EXPLANATION OF SIGNIFICANT DIFFERENCES

MODIFYING THE DECISIONS FOR THE SEDIMENT AND FLOODPLAIN / WETLAND OPERABLE UNITS TO ADDRESS DNAPL-IMPACTED SOILS AND SEDIMENTS

FIELDS BROOK SUPERFUND SITE - ASHTABULA, OHIO

2 figure

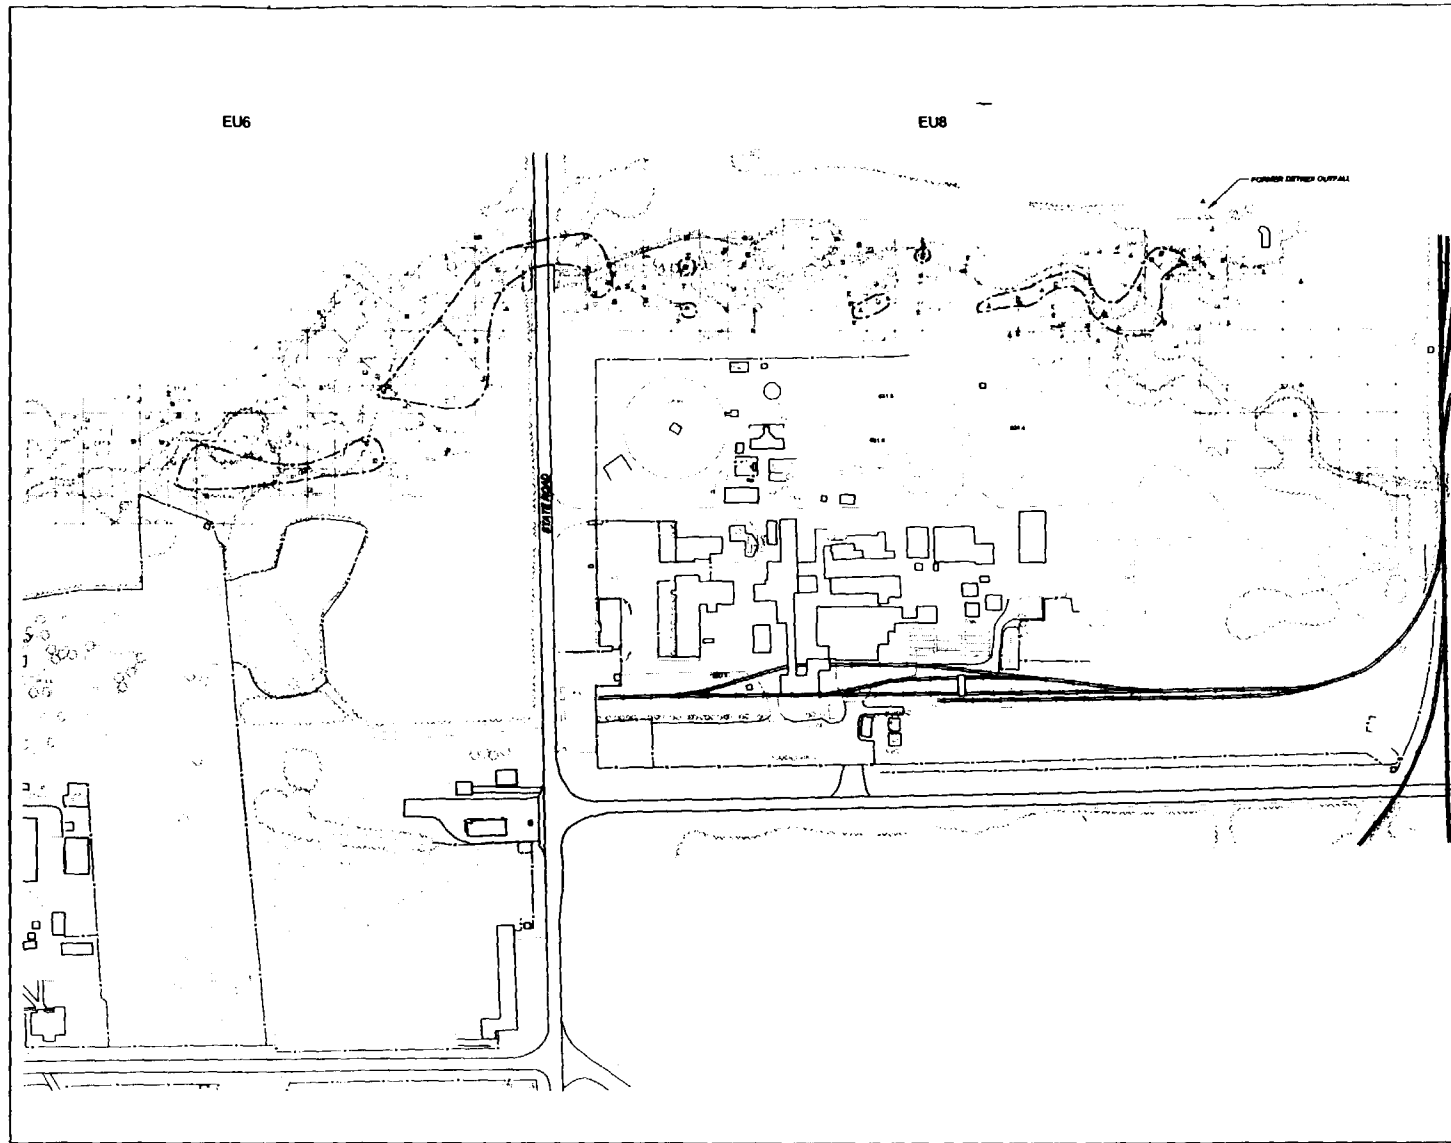
Based on the constituents in the DNAPL and the location of the DNAPL layer, it appears that Detrex Corporation was the source of DNAPL in the brook. See Figure 2 for the location of the former Detrex Tributary, which it is believed served as a historical conduit for the discharge of wastewater to Fields Brook. Figure 3 shows the outfall point where the former Detrex Tributary entered the brook and shows the approximate extent of DNAPL in Exposure Unit 8 and Exposure Unit 6. The constituents of the DNAPL support the likelihood that the source was Detrex since the DNAPL in the brook is very similar to the DNAPL found below the Detrex facility, which is being addressed under the Source Control ROD.

Figure 4 - 1 Low Temperature Thermal Desorption System Block Flow Diagram

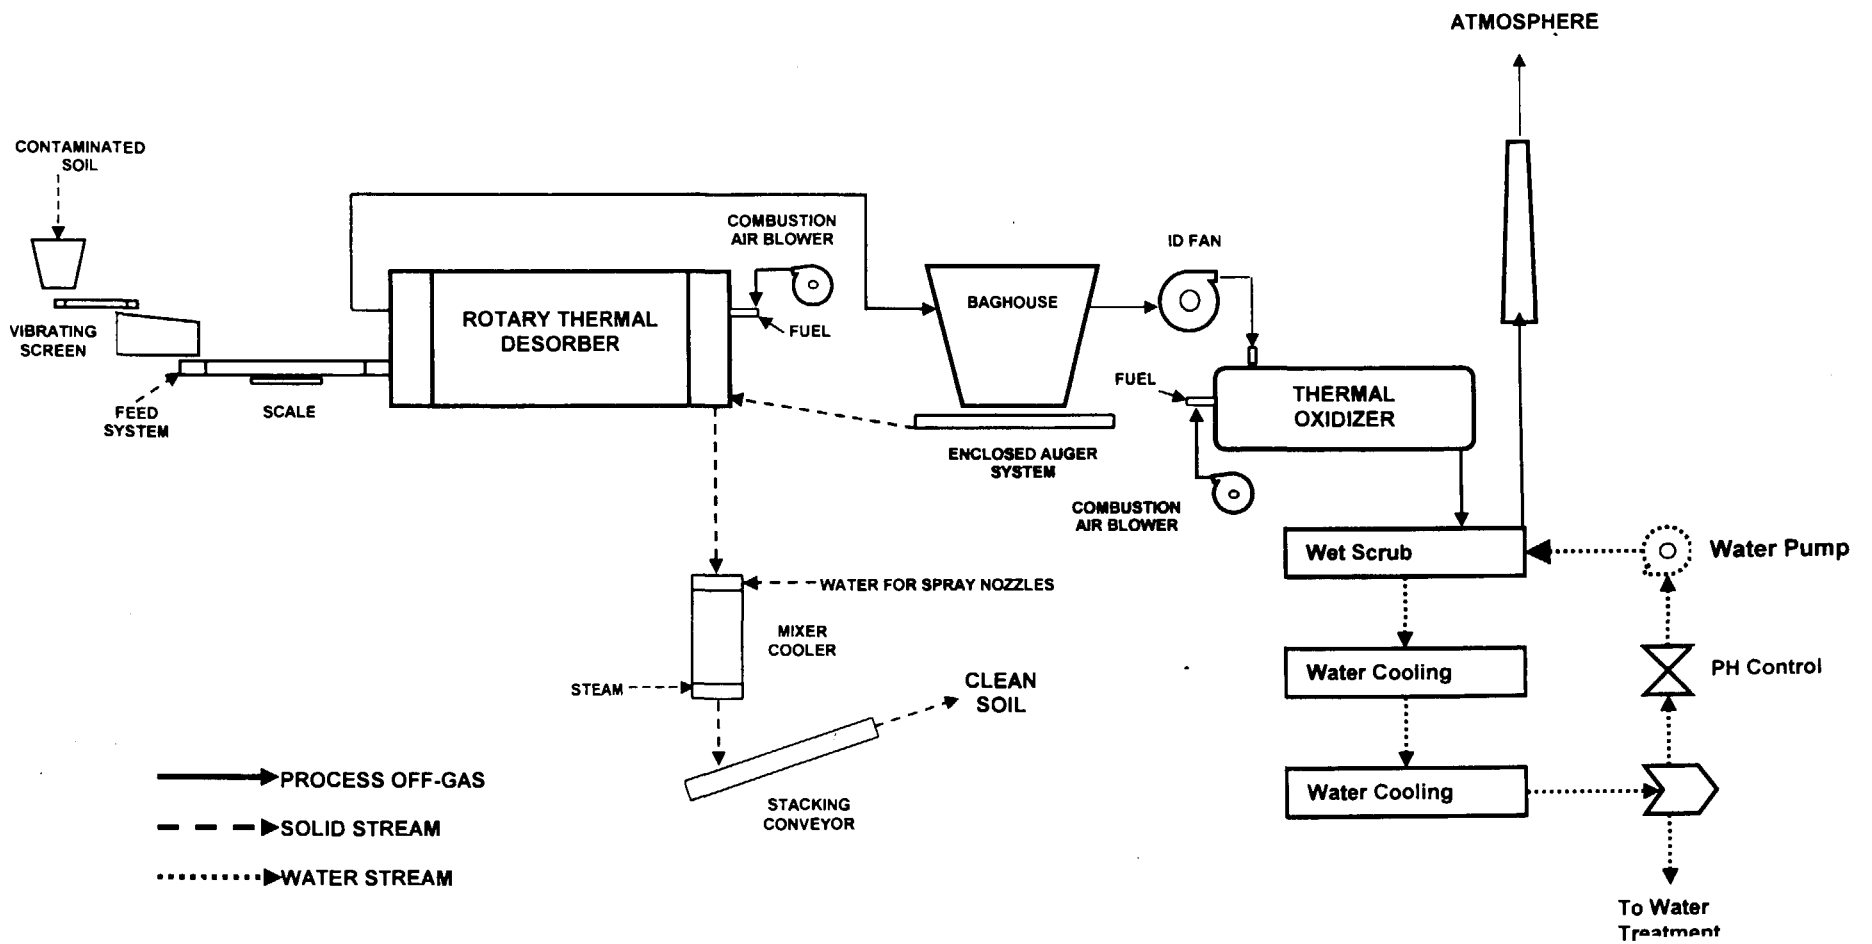
The Work Settling Defendants for the Sediment and Floodplain/Wetland Operable Units have proposed a Low Temperature Thermal Desorption unit for treatment of DNAPL-impacted soil and sediment. See Figure 4 for a description of the treatment process. U.S. EPA has determined that this unit must meet the requirements of 40 CFR Part 264, subpart O because it utilizes a thermal oxidizer to destroy contaminants in the gas stream.

Prior to full-scale operation, the thermal treatment system must demonstrate its ability to treat site contaminants and to meet air regulations consistent with an approved Performance Demonstration Plan. For treatment of soil and sediment that contain less than 50 ppm total PCBs, the thermal treatment system is required to meet a Destruction Removal Efficiency (DRE) of at least 99.99%. For treatment of soil and sediment that are known to contain or are likely to contain PCBs at a concentration at or above 50 ppm, the DRE must be at least 99.9999%. If the volume of DNAPL-impacted soil and sediment that contains PCBs at or above 50 ppm is determined to be too small to warrant treatment on-site at a DRE of 99.9999%, the Settling Defendants may elect to send this portion of the DNAPL-impacted soil and sediment off-site for incineration. Any DNAPL-impacted soil and sediment that contains PCBs at a concentration at or above 500 ppm must be treated off-site.

The Performance Demonstration Plan shall verify that the stack gas meets emission limits for particulates, VOCs, SVOC, PCDD/PCDF, and metals. Once the system is in operation, continuous emissions monitoring shall be performed for CO, CO₂, and THC. SO₂ and No_x will be monitored on a periodic basis.
